E-3 AWACS
CORROSION PREVENTION ADVISORY BOARD
(CPAB)

12 JULY 1990
TINKER AFB, OK

E-3 CORROSION PREVENTION ADVISORY BOARD MINUTES
12 JULY 1990

FIGURE 7. LIGHT INSTL, EXTERIOR EMERGENCY EXIT
POWER SUPPLY INSTL, EXTERIOR EMERGENCY EXIT (SHEET 1)

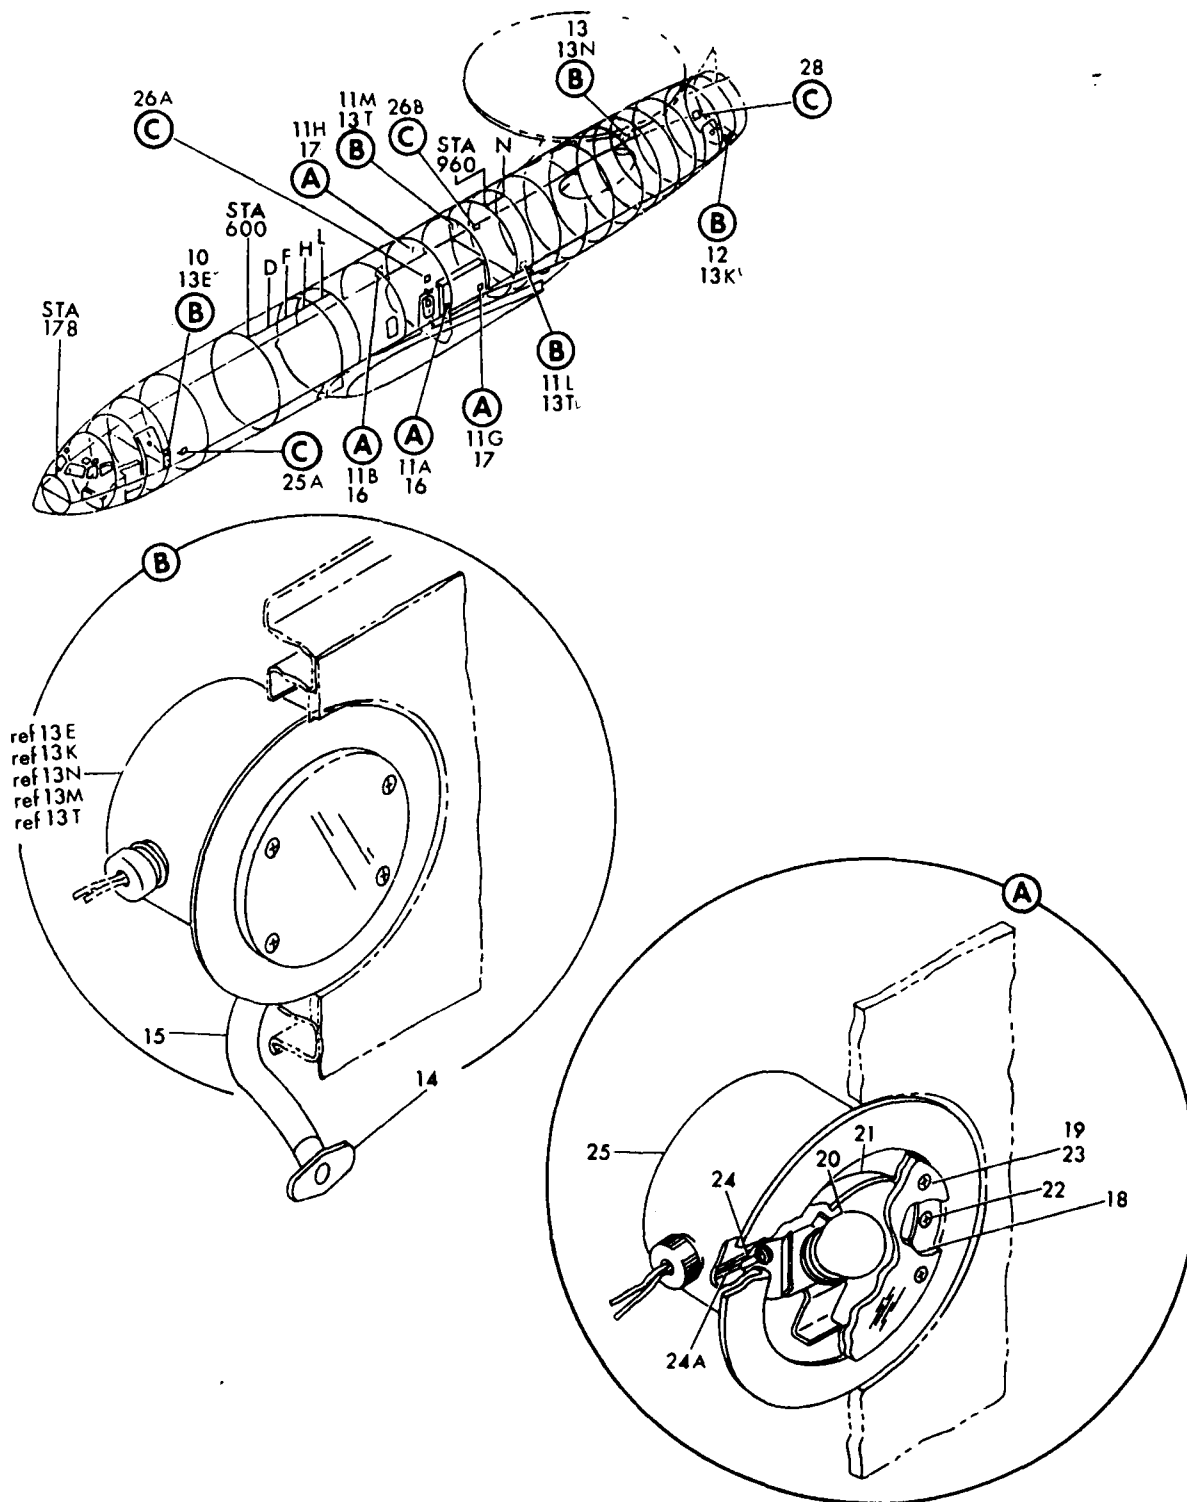
DRAWING(S): 204-56168, 30-0431/-0432		
	NAME: HFw Franz-Josef Deckers ORGANIZATION: HAEWF E-3A Comp TELEPHONE: 01-49-2451-63-2451 DATE SUBMITTED: May 1988		TO(S): 1E-3A-4-33-1 FIGURE: 33-02-07 INDEX: WORK UNIT CODE: 44A00		
	PROBLEM: Emergency exit lights located by the emergency exits above the wings collect moisture and subsequently corrode. A drain hole exists, but tends to clog up and prevent drainage.				
	RECOMMENDED ACTION: Investigate corrosion/drainage in the emergency exit lights and implement a solution.				
	(USE CONTINUATION SHEET IF NECESSARY)				
C P A B A C T I O N	STATUS: 26 Aug 1988: TCTO is being issued to inspect/remove corrosion in light housing assemblies per existing T.O. procedures and notify OC-ALC/MMKRA of any damage beyond T.O. limits. The TCTO also includes instructions to fill all the space in the housing below the drain with MIL-S-81733, smoothing out the sealant to slope toward the drain. MIL-C-85054 will then be applied to the inside of the light housing prior to light reinstallation, and apply MIL-L-87177 to the socket and base of the light bulb. T.O. 1E-3A-6 inspections will be changed to require disassembly to inspect for standing water and apply CPC.

E-3	CORROSION PREVENTION ADVISORY BOARD	ACTION ITEM #: 88-12
<u>CONTINUATION SHEET</u> RECOMMENDED ACTION:		
STATUS: July 1990: TCTO has already been written by MMKRTA but currently on hold for parts. Kitproof is also on hold. Reflector assy, P/N 31-1560-1 is unavailable at this time.

SEE NOTE ON PARTS LIST PAGES
FIGURE 14A. CONTROL INSTL, RUDDER (SHEET 1)

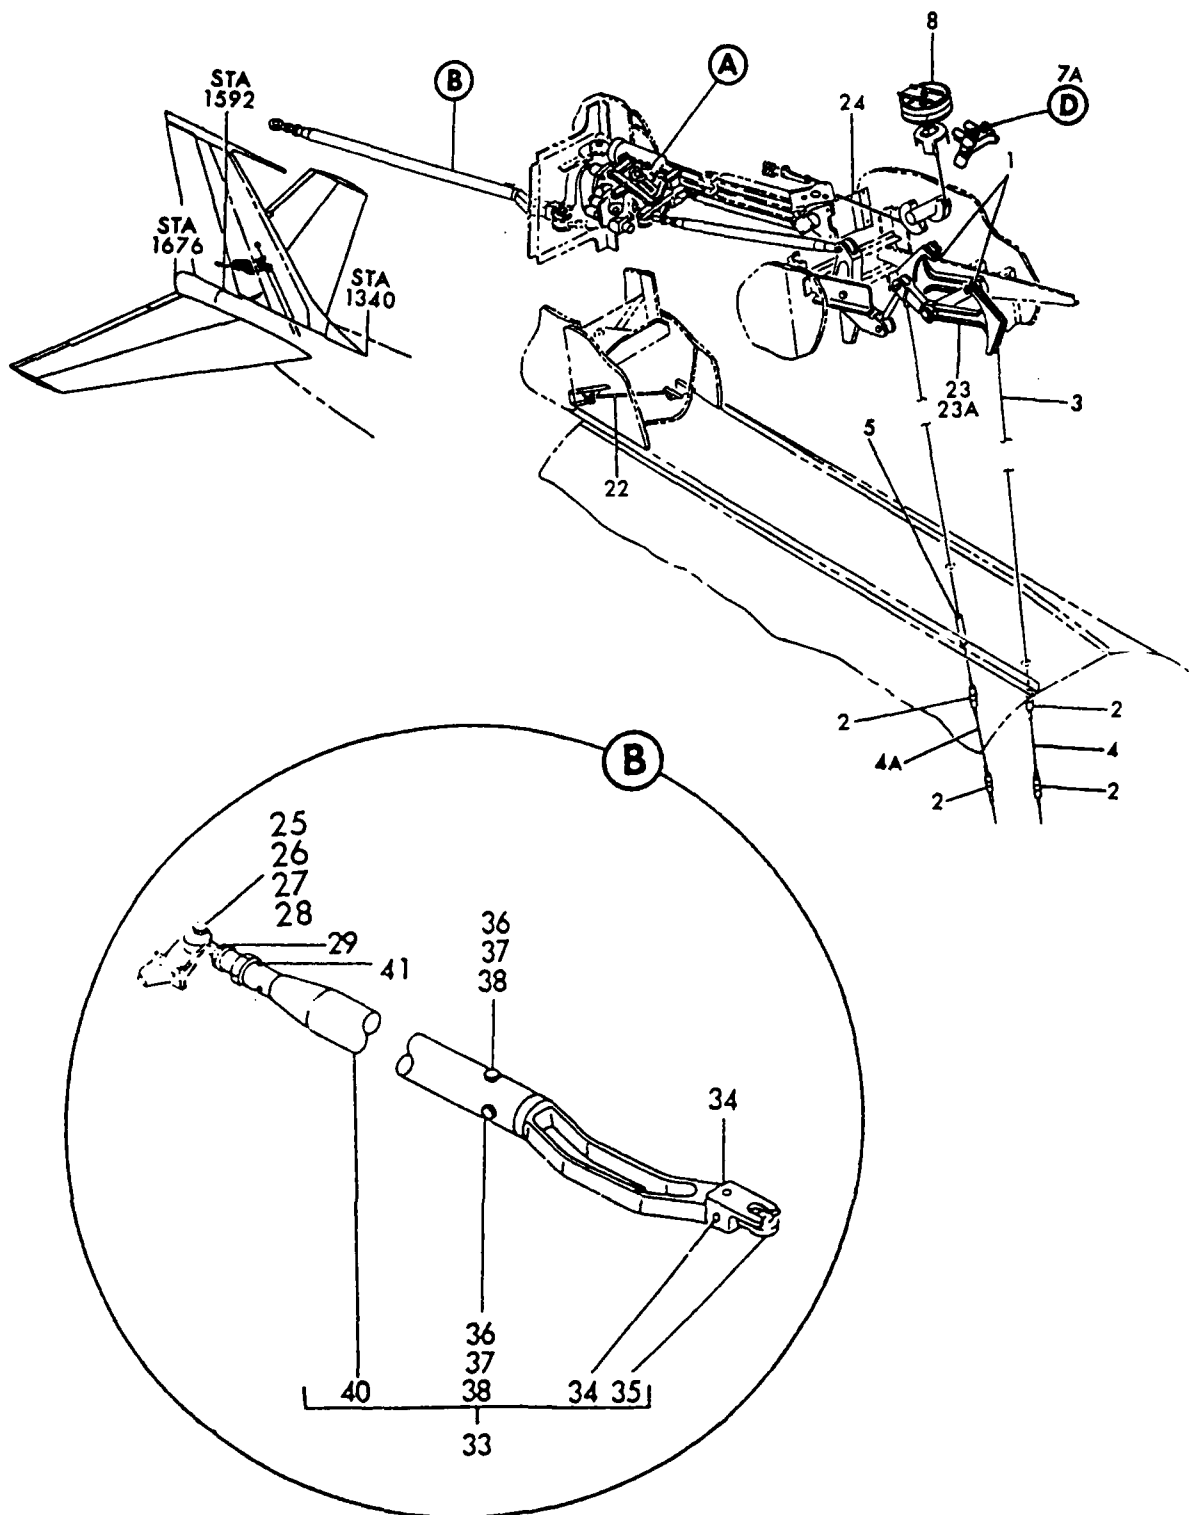
E-3		CORROSION PREVENTION ADVISORY BOARD		ACTION ITEM #: 88-13	
O R I G I N A L T O R	SUBJECT: Rudder Control Rod		BACKGROUND DATA:		
			PART NUMBER: 69-14346-2, 69-14345-3		
			NSN: DRAWING(S):		
	NAME: HFw Franz-Josef Deckers ORGANIZATION: NAEWF E-3 Comp. TELEPHONE: 01-49-2451-63-6215 DATE SUBMITTED: May 1988		TO(S): 1E-3A-4-27-1 FIGURE: 27-09-014A INDEX: 33 WORK UNIT CODE: 14ACA		
PROBLEM: After removing the rod end bearings, NATO workers drained as much as one liter of water out of rudder control rod.					
RECOMMENDED ACTION: Identify proper drain hole configuration for the rudder control rod.					
(USE CONTINUATION SHEET IF NECESSARY)					
C P A B A C T I O N	STATUS:				
	9 SEPT 1988: The rudder control rod is made from 2024 T3 aluminum and was designed to be a closed system. Drain hole configuration is attached				
	MMKRA will write an Engineering Change Order (ECO) against the drawing and issue a TCTO to ensure drain holes and interior finishes are added to the rudder control rods.

15 NOV 1988: WR-ALC/MMEP cautioned against drilling such a small drain hole. Boeing will provide justification for the .15 +/- .01 inch hole recommended. Stress considerations may require limiting the size of the drain hole. WR-ALC recommended the minimum hole size as .25 inches.				
(continued)					
ACTION OPR(S): OC-ALC/MMKRA		POINT(S) OF CONTACT: Vince Foster		EST. COMPLETION DATE: Oct 1989	
STATUS: OPEN DATE CLOSED: FINAL DISPOSITION:

An engineering change order (ECO) is being made to the Air Force drawing. After the drawing is changed, a TCTO will be issued to clean and finish the interior of the rudder control rods, and drill the drain hole.

TCTO will require 552 AWACW/NAEWF E-3A Component/RSAP personnel inspect rudder control rods during phase, drill holes for drainage, and change out for rework if corrosion is detected inside the control rod.

TCTO has been completed and will be published soon. During kit proof, hole was too large and drilled completely through part. TCTO revised to reduce hole diameter to 3/16" and only drill lower side of rod. It was also discovered that attach hardware was loose, corroded, or missing. MMKRA will request all users initiate a one time inspection at O/I for corroded, missing, or loose hardware, and replace if necessary.

Figure 10-21. HF Transmit Components Installation, Wing Tip

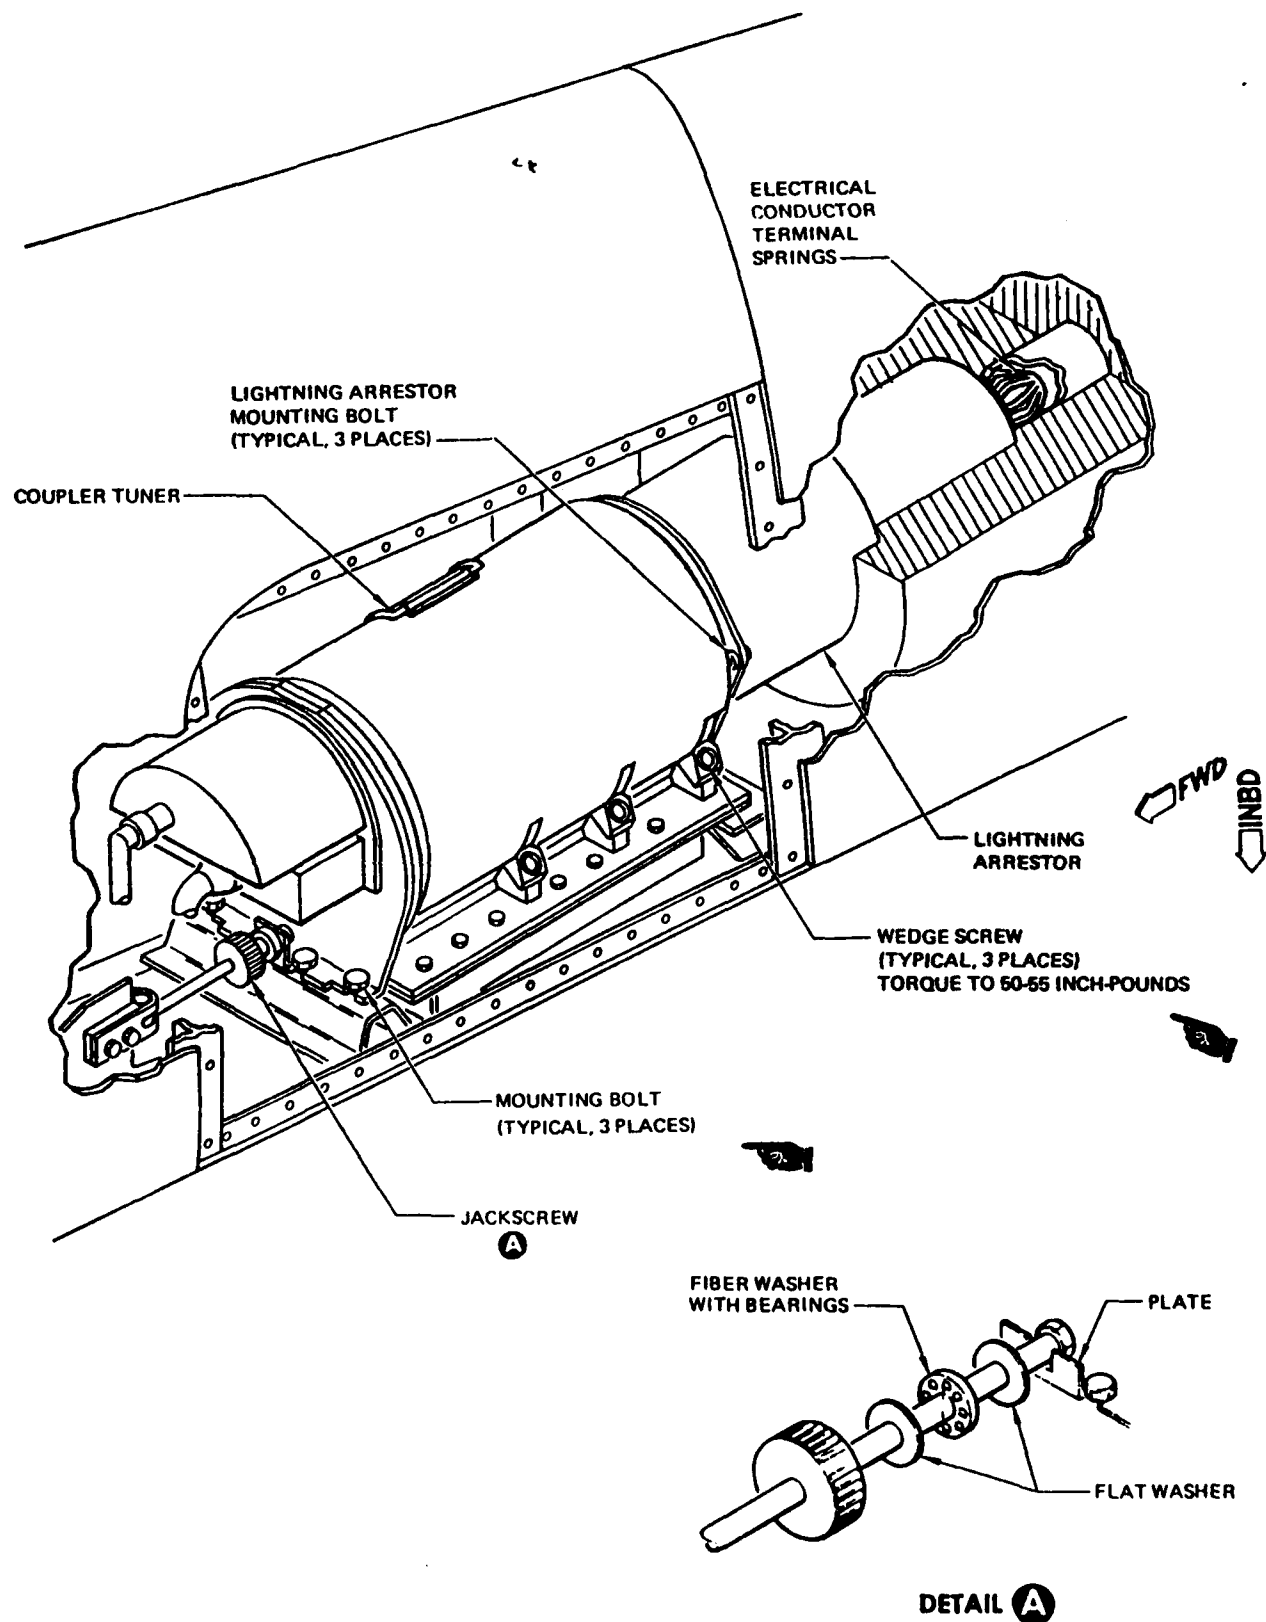
DRAWING(S):		
C P A B A C T I O N	NAME: HFw Franz-Josef Deckers ORGANIZATION: NAEWF E-3 Comp. TELEPHONE: 01-49-2451-63-6215 DATE SUBMITTED: May 1988		TO(S): FIGURE: INDEX: WORK UNIT CODE:		
	PROBLEM: NATO discovered severe corrosion on HF antennas located in the E-3 wingtips as well as corrosion on wingtip structure. Water remains trapped in the wingtips after washing. Adding more drain holes in this area may help.				
	RECOMMENDED ACTION: Identify manufacturing processes and materials and configuration of HF antennas located in E-3 wingtips. Identify possible solutions to inhibit corrosion.				
	(USE CONTINUATION SHEET IF NECESSARY)				
C P A B A C T I O N	STATUS: 1 July 1988: Boeing is issuing a service letter regarding corrosion on the baseplate of the antenna coupler. Material changes were made to the HF antenna but did not affect the lightning arrestor or coupler. Adding drain holes may help the problem. The lightning arrestor base is copper alloy C36000 with silver plate per MIL-SPEC QQ-S-365, Type II, Grade A with a thickness of .0001 - .00015.

OC-ALC/MMKRA will take responsibility for installing another drain hole to allow condensation to drain and allow more air to circulate in to the area, and to change tech data to require a more frequent inspection of the wingtip antenna. Boeing will investigate the possibility of treating the foam with a material to keep it from absorbing water.

Boeing was unable to define any other measures to inhibit moisture accumulation in the foam. A redesign to eliminate condensation and provide better corrosion protection is beyond the scope of this task, and will require an engineering services task.

Boeing is preparing a SOW for an EST to provide tooling and procedures for eliminating the water from the foam cells and injecting grease into the foam, thus displacing any water.

OC-ALC/MMKRA is making changes to install drain hole and prepare appropriate drawing/tech order changes. EST 90-E3B2-13, Development of Tools/Procedures to Prevent Corrosion in HF Wingtip Antenna, has been prepared and the necessary paperwork is being processed to put task on contract. OC-ALC/MMKRA is coordinating a separate Statement of Work for a potential EST to investigate/provide repair procedures for cracking in the foam.

OC-ALC/MMKRA is generating TCTO to drill drain hole and add leveling compound. TCTO will be finished by next CPAB.

Mr. Richard Elmslie from Boeing reported that EST 90-E3B2-13 has been started. Boeing will take action to investigate the need of foam surrounding HF antenna.

Reported foam cracking was investigated by MMKRA and found not to be a significant problem. EST would require an exhibit, which is unavailable. No EST will be pursued, and any future problems will be corrected on a case-by-case basis.

E-3 LANDING GEAR DRAG STRUT / SHOCK STRUT BOLT

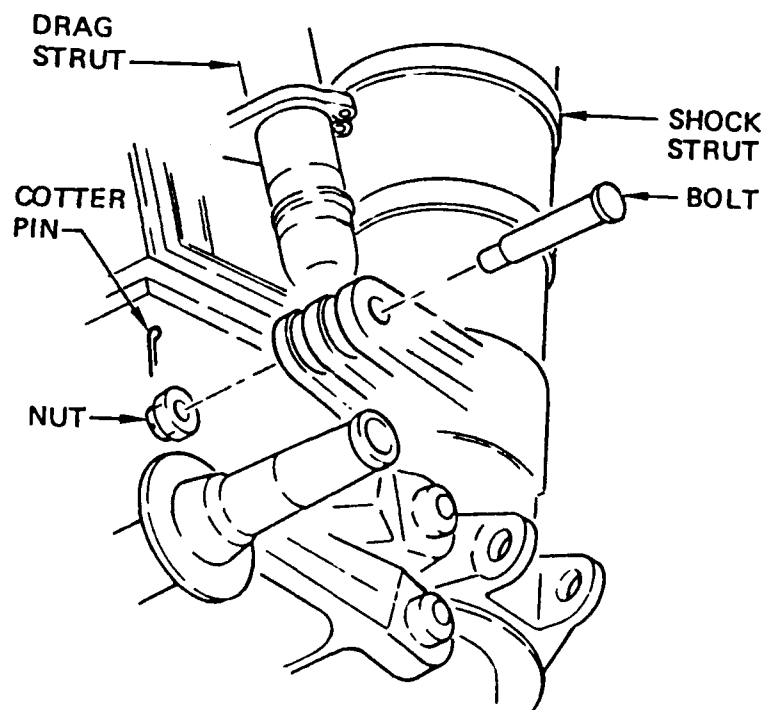
MIL-S-81733 works better than MIL-S-8802, however bolts are still difficult to remove. DINOL AV5 was applied in Dec 88 and Mar 89, and bolts were more easily removed than before, yet bolts were still not easily removed. It was suggested that a product used by European commercial airlines called MASTINOX (See AI 89-04) be tried.

NAEWF E-3A Component has no results because it only has been approximately one year since the application of MASTINOX to landing gear bolts.

Figure 3-6 Stabilizer and Elevator Access Panels (Sheet 1 of 8)

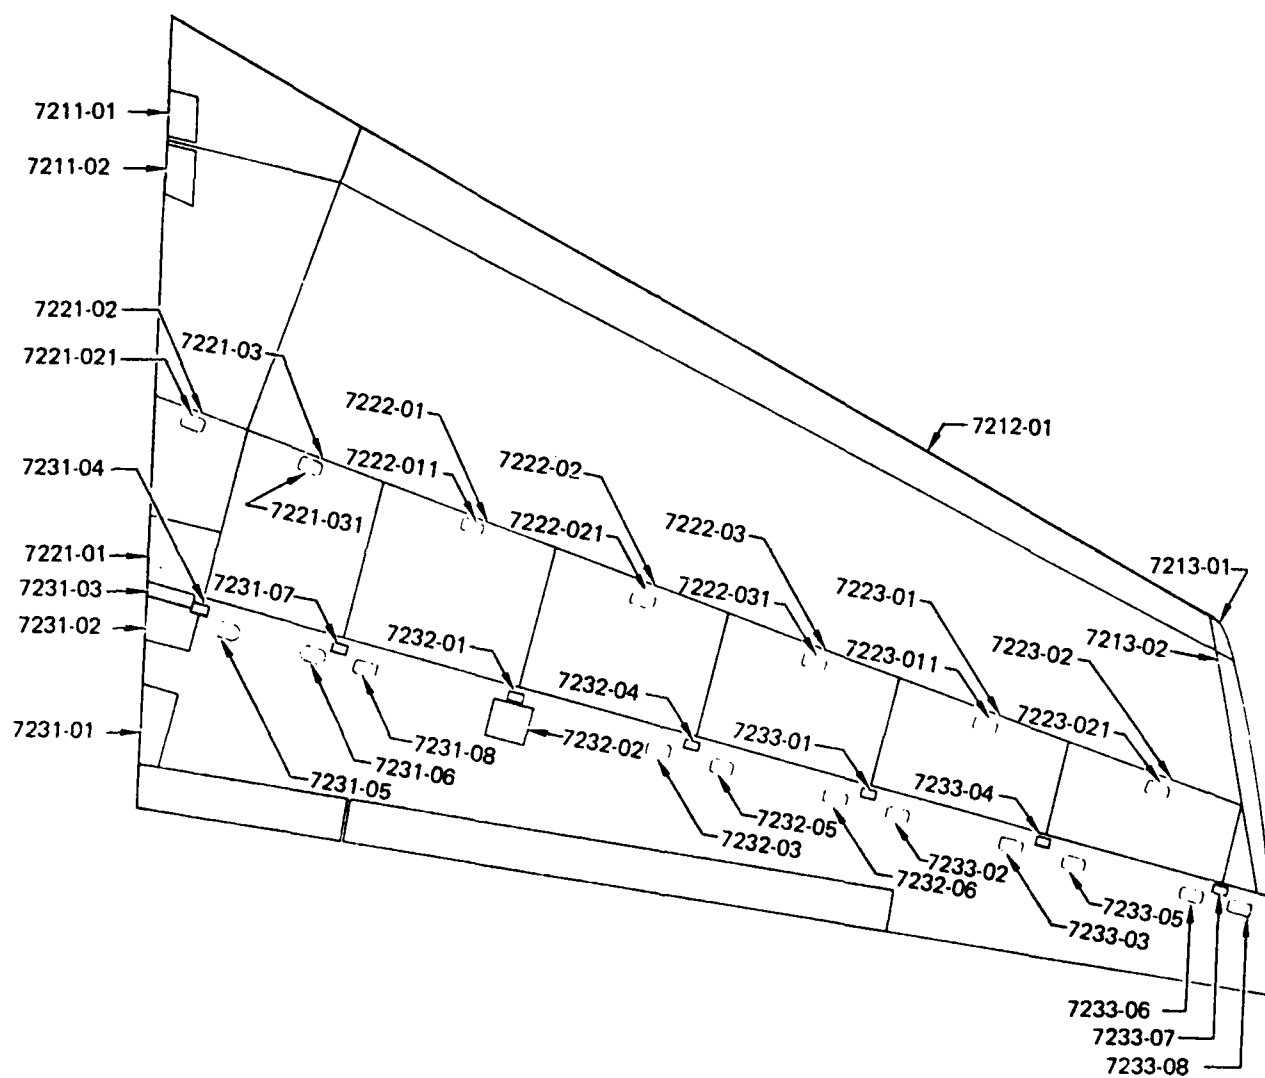
E-3		CORROSION PREVENTION ADVISORY BOARD		ACTION ITEM #: 88-25	
O R I G I N A L T O R	SUBJECT: Elevator Thrust Hinge Access Panel		BACKGROUND DATA:		
			PART NUMBER: Panels 7231-03, 8231-03		
			NSN: DRAWING(S):		
	NAME: Hfw Franz-Josef Deckers ORGANIZATION: NAEWF E-3A Comp TELEPHONE: 01-49-2451-63-6215 DATE SUBMITTED: May 1988		TO(S): 1E-3A-23 FIGURE: 3-6 INDEX: WORK UNIT CODE: 11FDL, 11FGN		
PROBLEM: Standing water in this panel is a problem.					
RECOMMENDED ACTION: Initiate action to provide drain holes in the elevator thrust hinge access panels.					
(USE CONTINUATION SHEET IF NECESSARY)					
C P A B A C T I O N	STATUS:				
	2 Sept 1988: A TCTO is being issued to drill a 0.30 inch diameter drain hole on the lower surface access panels (7231-03 and 8231-03) 3 inches inboard of the existing inboard drain hole and on the same centerline of both existing drain holes. MIL-S-81733 is then applied to channel water toward the new drain hole. ECO being issued to change configuration on drawings.

12 March 1990: Action Item originally closed Sept 1988 after ECO prepared and MMKRTA tasked to draft TCTO. No action has been taken regarding issue of TCTO. Action Item reopened at March 1990 CPAB due to lack of TCTO. OC-ALC/MMKRA/MMKRTA will ensure TCTO is completed as necessary.				
	July 1990: TCTO will not be generated due to the forging of the material. MMKRTA will develop ACI procedures to apply CPC, and add a leveling compound. Fasteners prohibit drilling of drain hole.				
ACTION OPR(S): OC-ALC/MMKRA/MMKRTA		POINT(S) OF CONTACT: Clark Nowlin/Wilburn Mitchell		EST. COMPLETION DATE:	
STATUS: OPEN DATE CLOSED: FINAL DISPOSITION:
